File FPP-1996-240

Name: The Glen at Horizon – SE Corner 7th Street and Horizon Drive

RE: The Glen at Horizon—Building Modifications

RE: The Glen at Horizon - Building Modifications

96045
 The Glen at Horizon
 Subdivision
 Modified Site Plan
 3 of 23

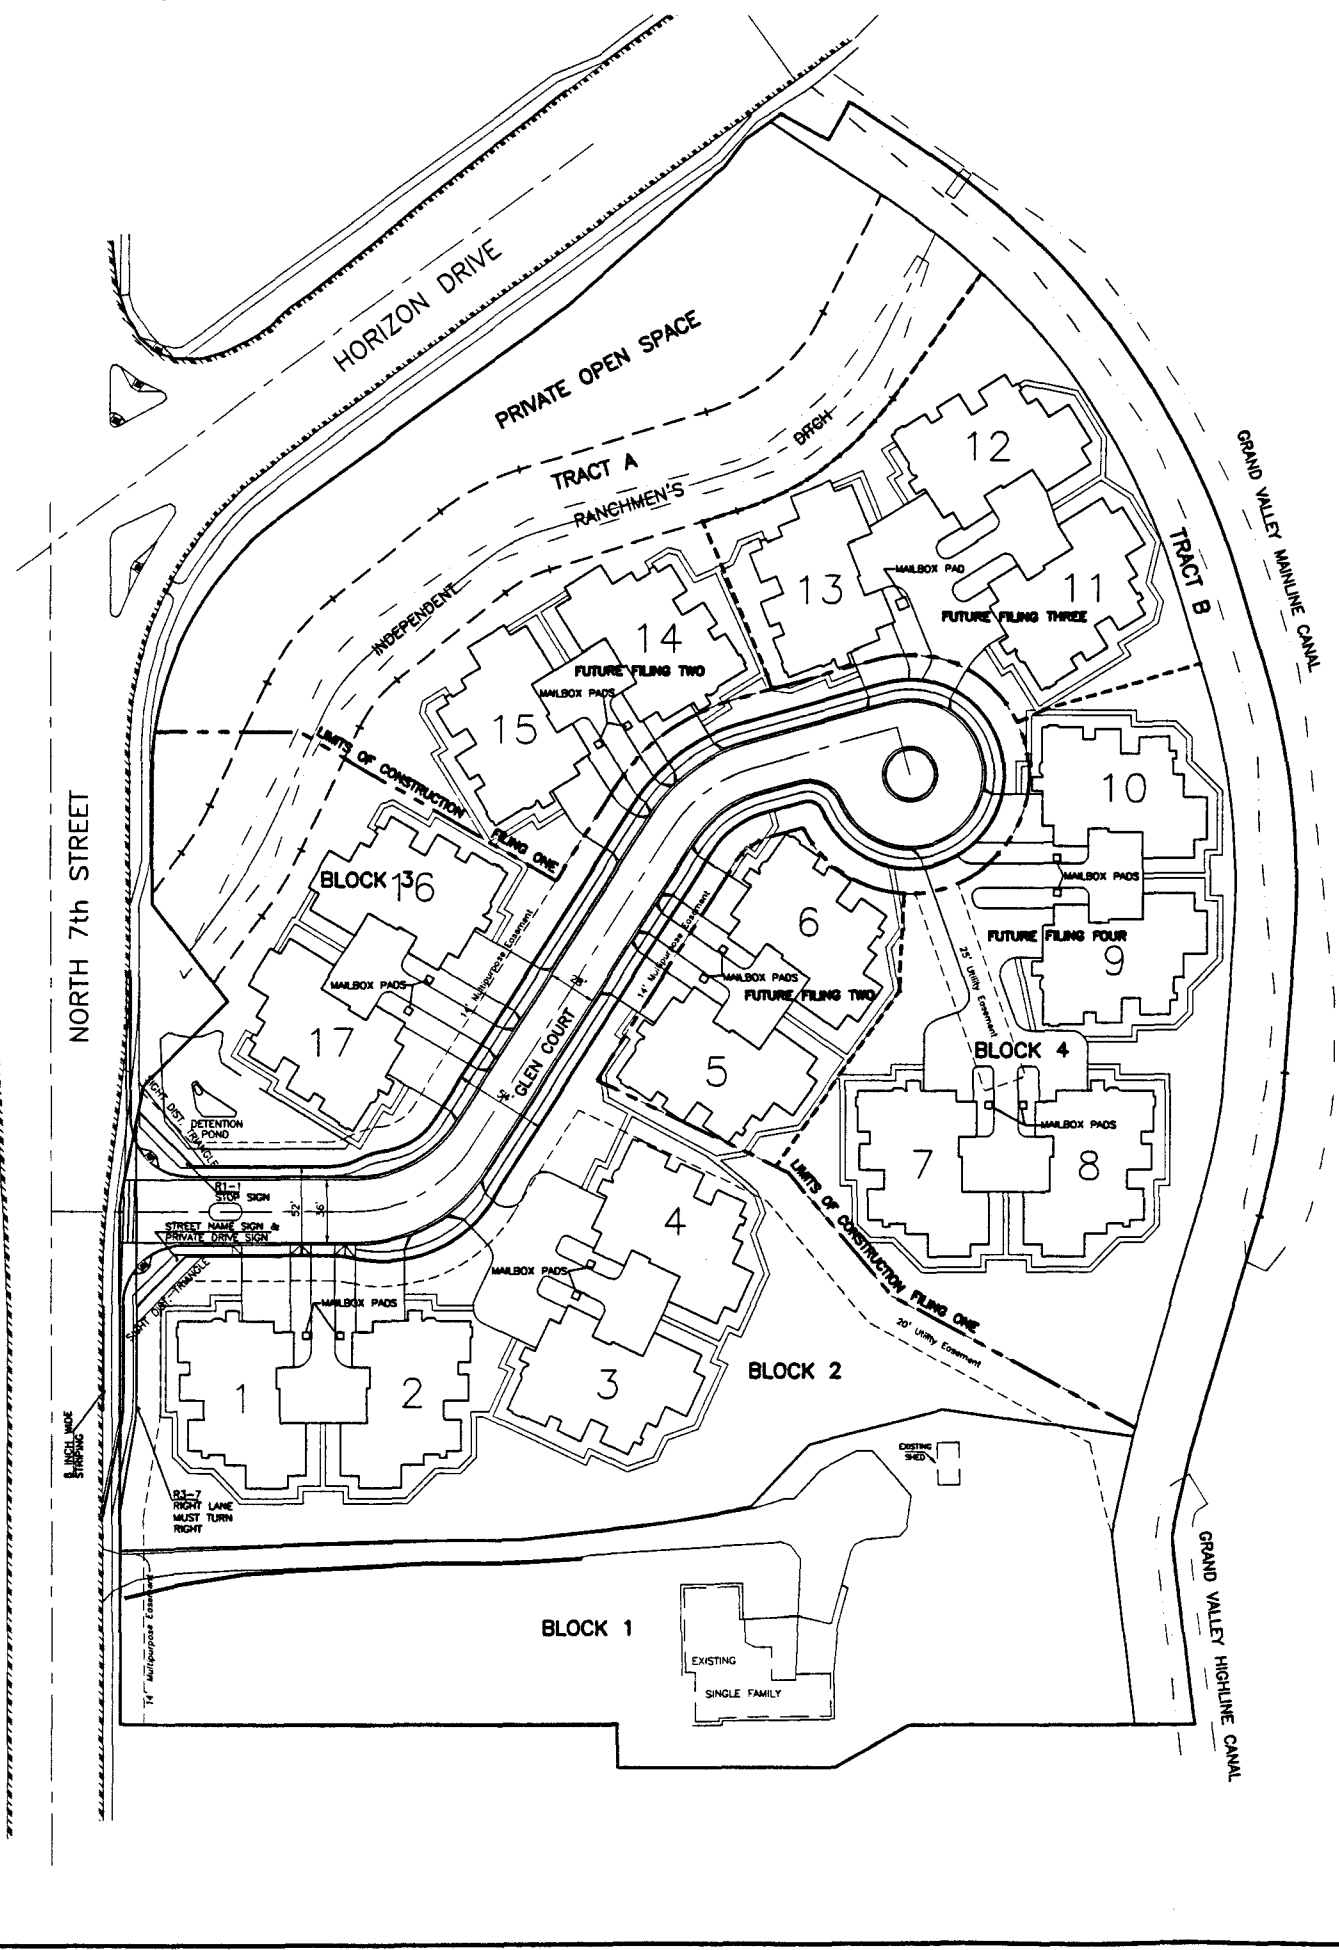
1. The street is intended to be private, therefore the plat should dedicate it as easement.
2. Site Plan is labeled Sheet 4 of 23 - appears it should be Sheet 3. The street cross sections are incorrectly labeled as right of way and the dimensions do not match.

GLEN COURT PLAN AND PROFILE
THE GLEN AT HORIZON SUBDIVISION
LANDesign
ENGINEERS • SURVEYORS • PLANNERS
250 GRAND AVENUE
GRAND JUNCTION, COLORADO 81501 (870) 245-4099
PROJECT NO. 98045 DRAWN BY: Jmm CHECKED BY: BCh APPR'D BY: BCh SHEET NO. 4 OF 23
DATE: OCT., 1998

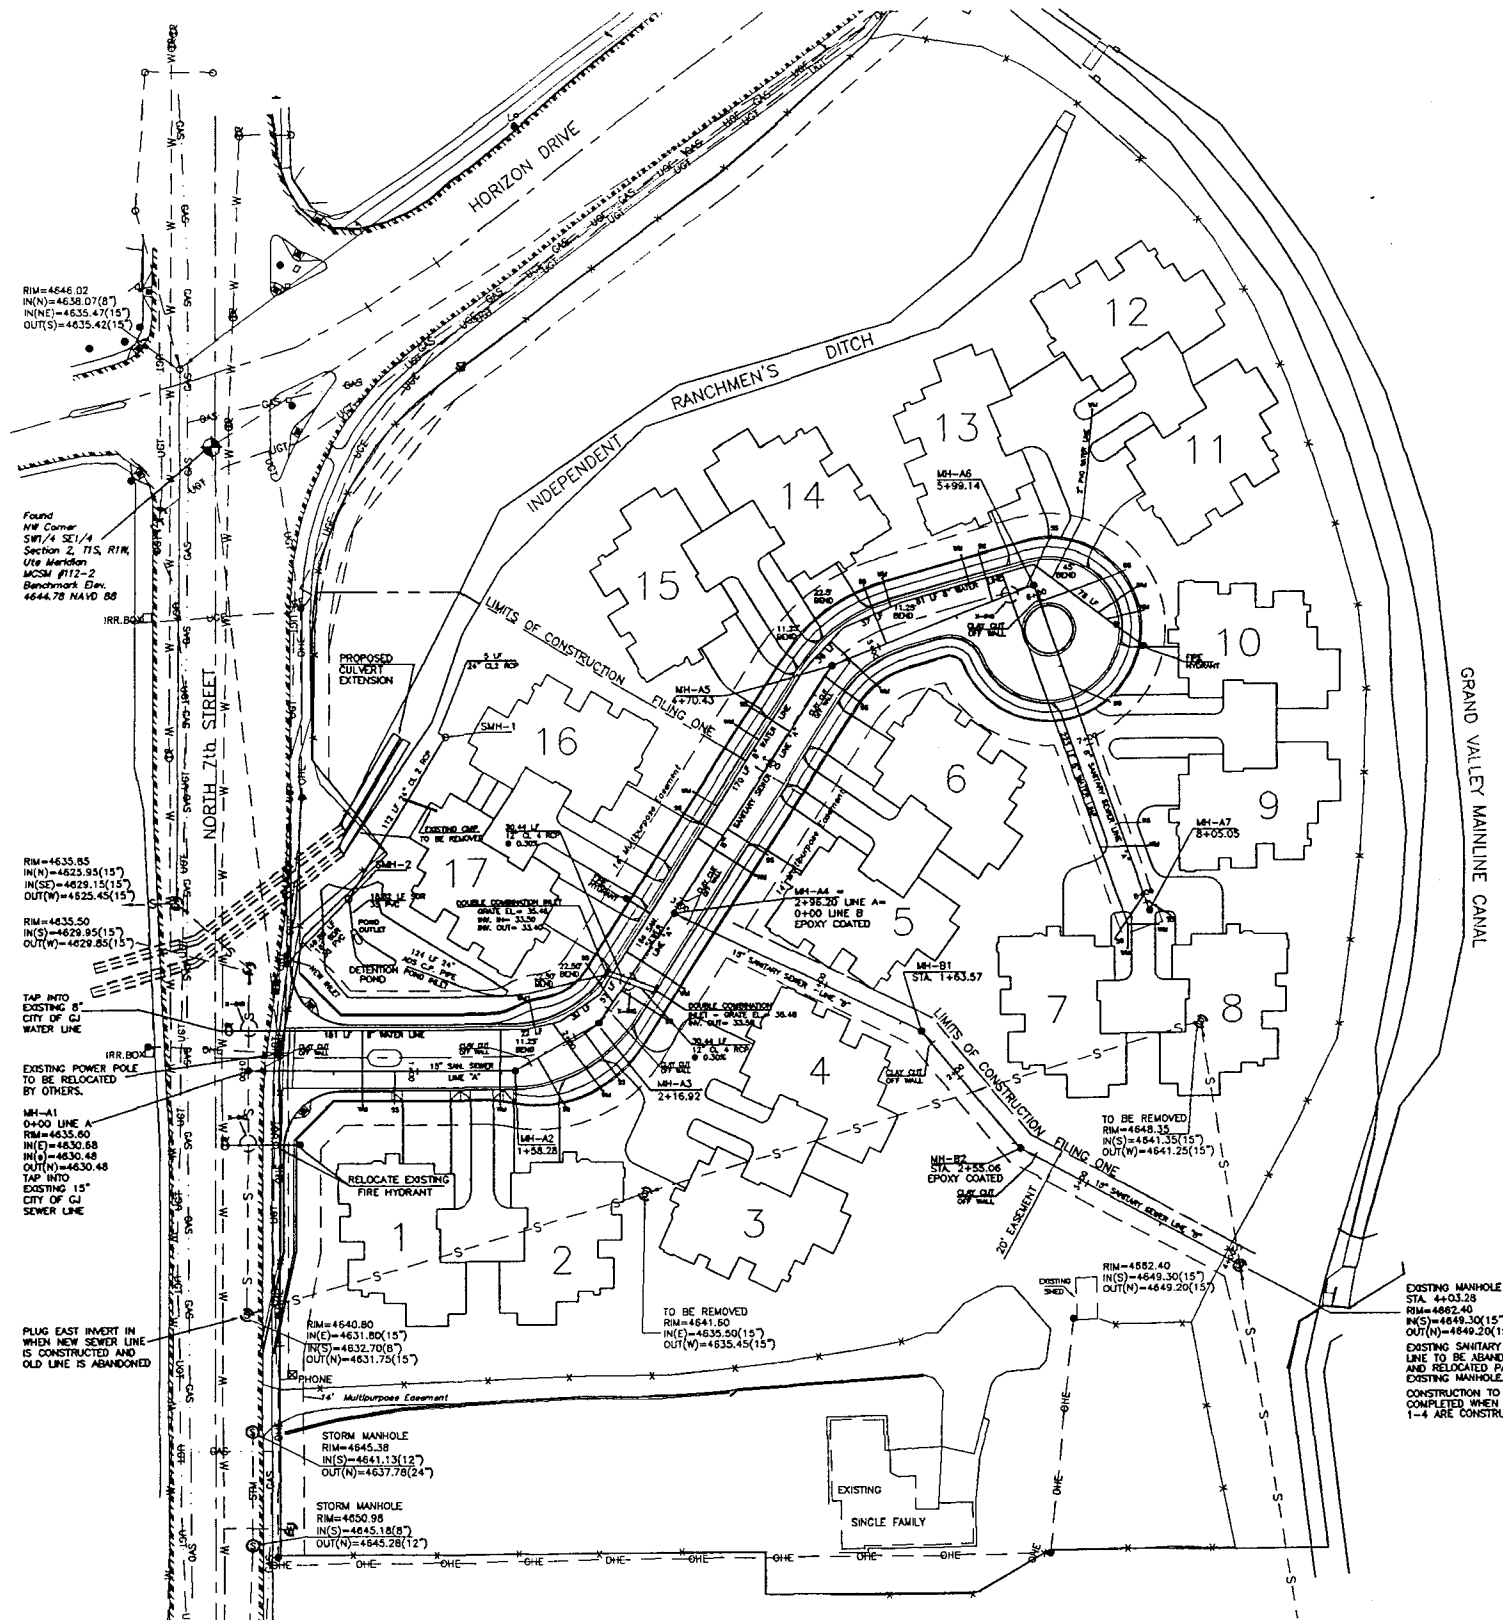
3. The other Sheet 4 of 23 - Glen Court Plan and Profile - The same problem as in #2 with the street profiles. Also, please provide stationing under the cross section to indicate the extents of each section.

UTILITY COMPOSITE
 THE GLEN AT HORIZON
 SUBDIVISION

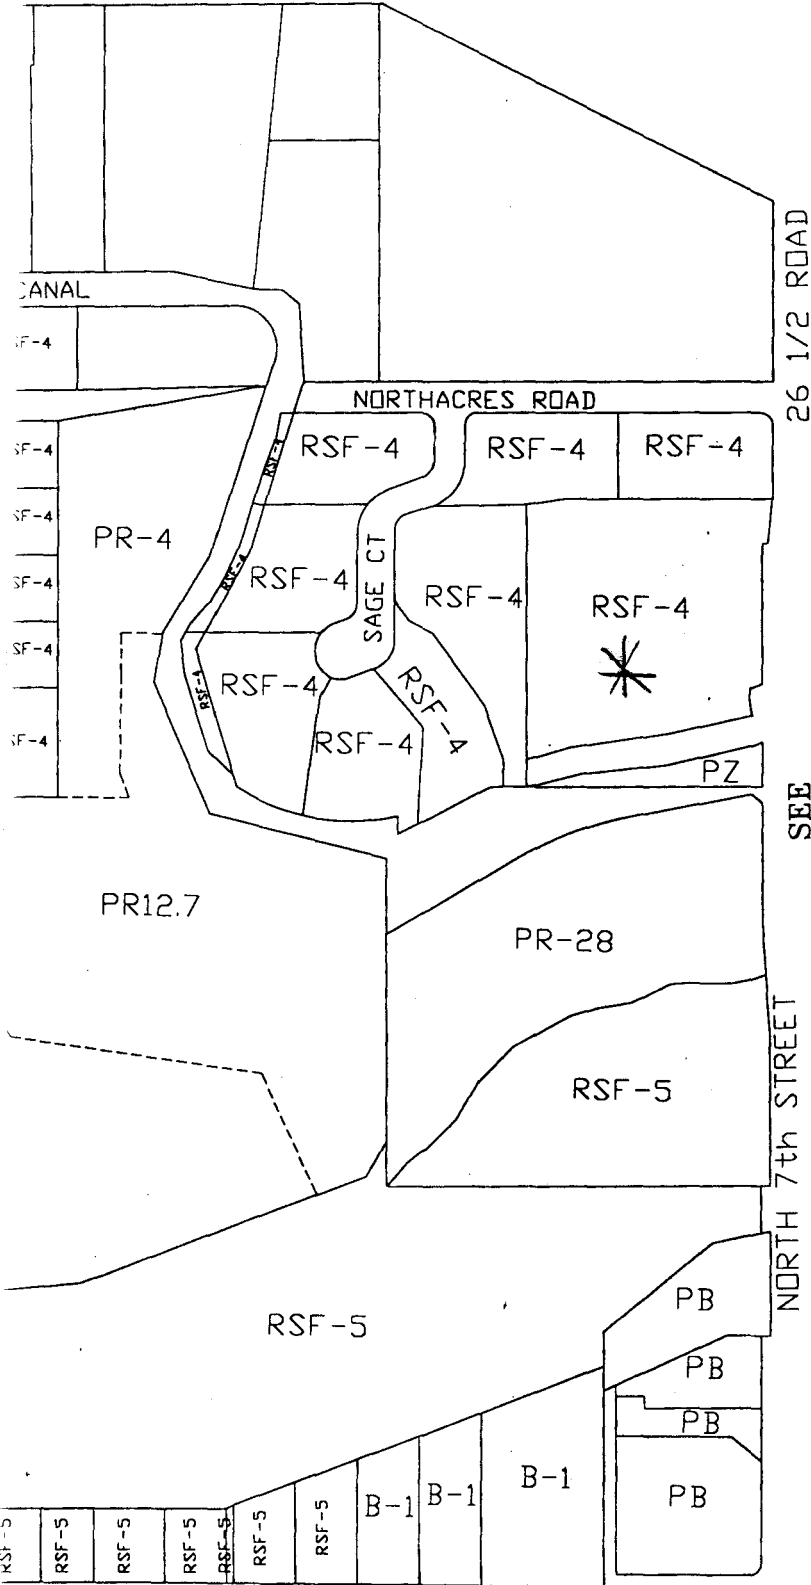
19. Utility Composite - sheet 11 of 23 - in order to access the 15" sanitary line, the city truck will need to drive in the easement. You will want to provide a surface capable of supporting a heavily loaded truck. If this includes the sidewalks, the concrete thickness will need to be at least 6".
